# Exchange of floats on ROTAX® Engine Type 912 and 914 (Series)

ATA System: 73-00-00 Fuel system

**MANDATORY**

Compliance with this Service Bulletin supersedes SB-912-065/SB-914-046, latest issue.

Fig. 2

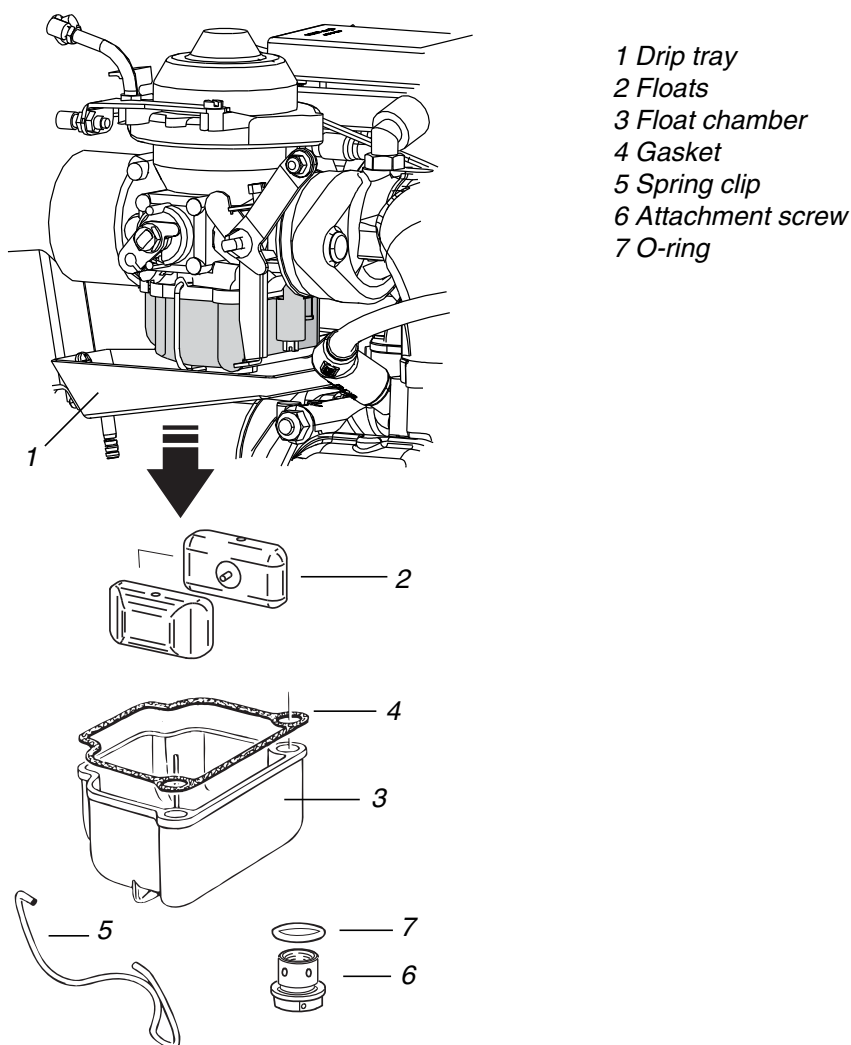
See Fig. 2.

Step	Procedure
1	Remove drip tray (1).
2	Visual inspection of the carburetor and its mechanical actuation.
3	Remove spring clip (5) or for ROTAX 914 Series remove safety wire, loosen cap screw (6) and remove with O-ring (7).
4	Remove float chamber (3), gasket (4) and the two floats (2)

Step	Procedure
1	Remove the gasket (4) from the float chamber and for ROTAX 914 Series exchange the O-ring (7).
2	Install float chamber (3) with gasket (4) and both floats (2).

Step	Procedure
3	Close spring clip (5) or for ROTAX 914 Series install the attachment screw (6) including O-Ring (7) and apply safety wire. Tightening torque of attachment screw 5.5 Nm (48.7 in.lb).
4	Install drip tray (1) and/or accessories according to the instructions of the aircraft manufacturer.
